## ZÁVAZNÝ SERVISNÍ BULETIN / MANDATORY SERVICE BULLETIN

TÝKÁ SE / CLARIFICATIONS: Installation of the fuse for the flap control servo-motor.

OVLIVNĚNÉ VÝROBKY / AFFECTED PRODUCTS: All TL 3000 Sirius aircraft furnished with the flap control system unit - Flopcontrol OPA

ČÍSLO BULETINU / NOTICE ID: 1.S.SI.2014

Diagram illustrating the insertion of the 7,5 A fuse into the flap control electrical circuit

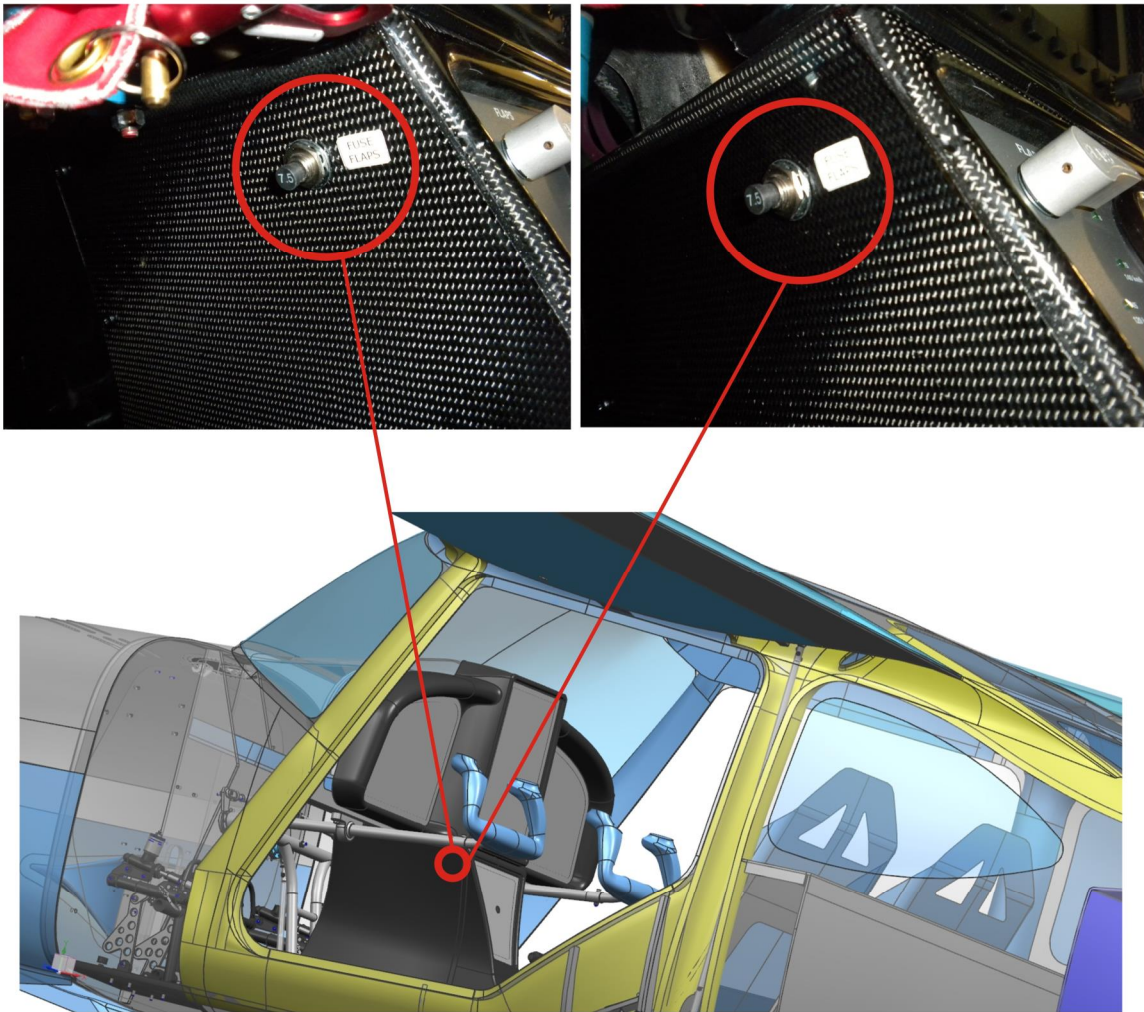
With an inaccurate rotation of the flap control handle, where the handle moves outside of the firmly set positions (flap closed, take-off position and landing), the end sensors of the flap control servo-motor become inactive. The servo-motor is then ejected outside of its position limits, becomes overloaded and subsequently its damage will occur. This condition can be eliminated by inserting a fuse into the electrical circuit of the flap control system unit, which will, in case of the overload, cut off the power supply to the servo-motor.

The objective of the above modification is to prevent the flap control servo-motor damage and the subsequent need for its costly replacement. This Service Bulletin describes the procedure of the flap control electrical circuit modification, so that it can be performed independently by the aircraft operators.

7,5 A fuse Tyco Electronics W23-X1A1G-7,5

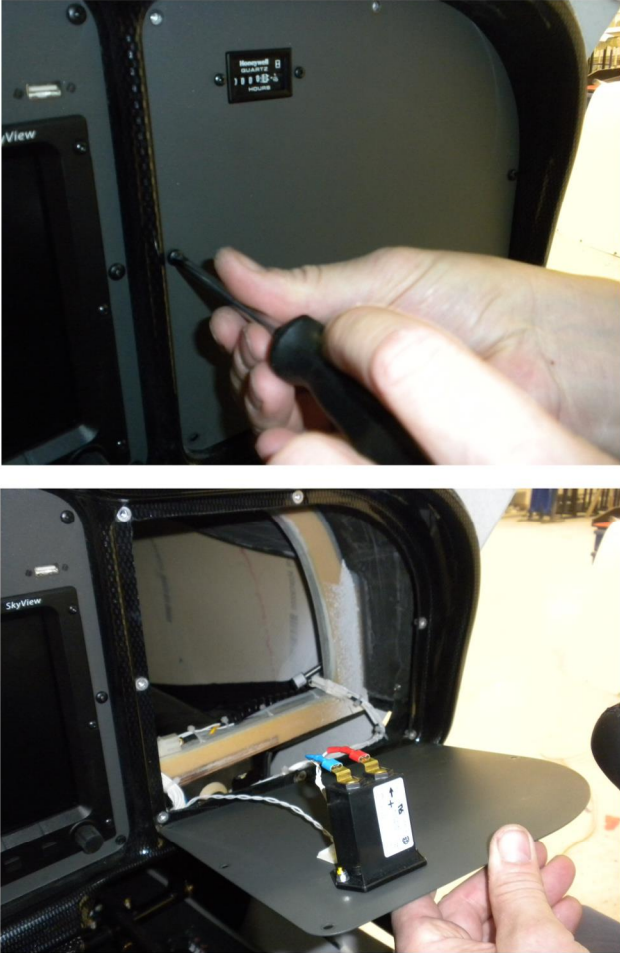
Step No.	Description of the modification steps
<p><b>1</b></p>	<p><b>The aircraft preparation</b></p> <ul style="list-style-type: none"> <li>- situate the aircraft into a suitable facility and secure the wheels with wedges</li> <li>- ensure that all switches are off and that the safety system is secured against activation</li> <li>- dismantle the top engine cover and disconnect the accumulator (+ pole)</li> </ul>
<p><b>2</b></p>	<p><b>The fuse preparation</b></p> <ul style="list-style-type: none"> <li>- prepare the 7,5 A Tyco Electronics W23-X1A1G-7,5 fuse</li> <li>- connect wires to the fuse connectors (2 x AWG 16, 2 x 600 mm délka) and secure connections as per picture below</li> </ul> <div style="text-align: center;">     </div>

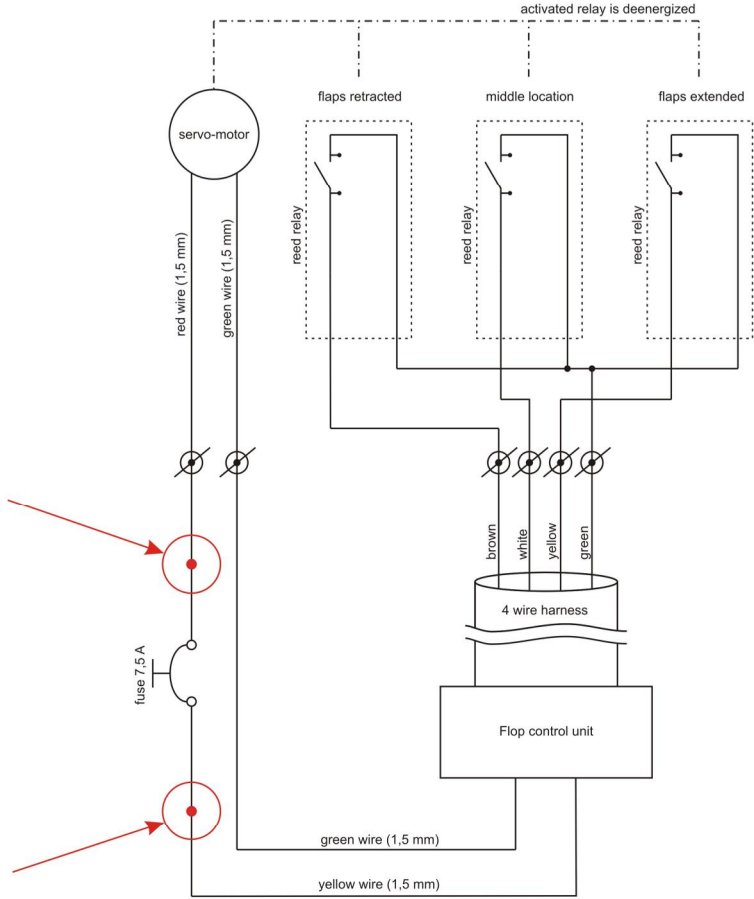
Step No.	Description of the modification steps
<p><b>3</b></p>	<p><b>Fuse installation</b></p> <p>- drill a hole into the center console (on the pilot's side) and install the fuse so that it does not obstruct free control system movement and other aircraft construction components in any way, and so that it is easily accessible by the pilot during flight (see picture below).</p> 
<p><b>4</b></p>	<p><b>A tag installation</b></p> <p>- Install a tag with the script: „ Fuse Flaps” into the center console near the fuse location.</p>

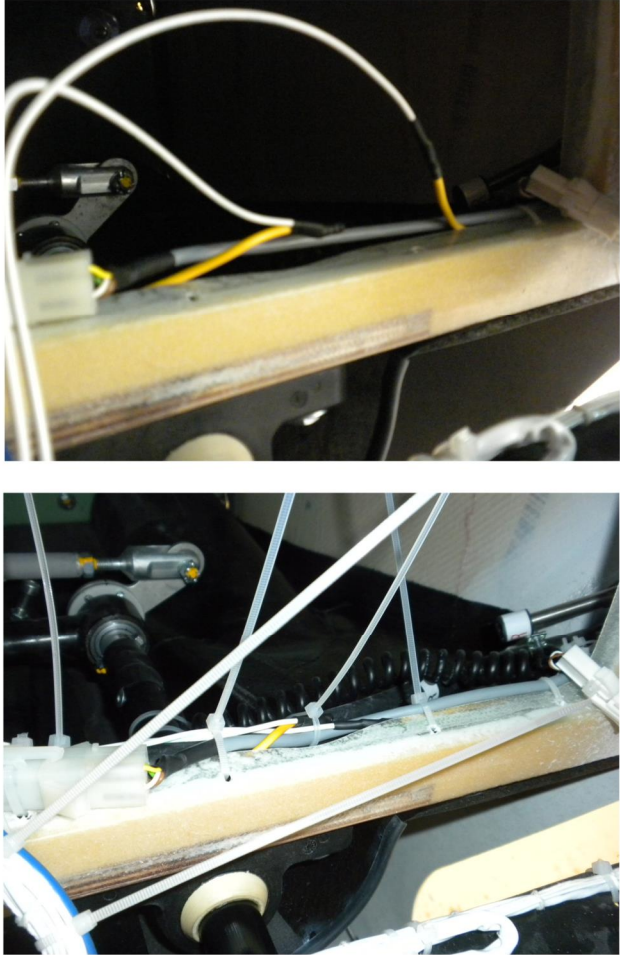
Step No.	Description of the modification steps
<p><b>5</b></p>	<p><b>The right instrument panel disassembly</b></p> <p>- remote the right instrument panel, located in front of the co-pilot's seat, so that the wires attached to the structure frame behind the instrument panel can be accessed. The instrument panel is fix in place by 7 screws. Take caution so that you do not during the cover disassembly damage the instrument furnishing or its cabling inside the instrument panel.</p> 
<p><b>6</b></p>	<p><b>Interruption of the servo-motor control wire</b></p> <p>- using a suitable tool, cut the yellow wire of the flap control el. circuit, located on the frame behind the instrument panel. Take caution: Make sure that you are cutting the correct wire and that you will not damage any of the other wires (see pictures and the diagram on the following page).</p>
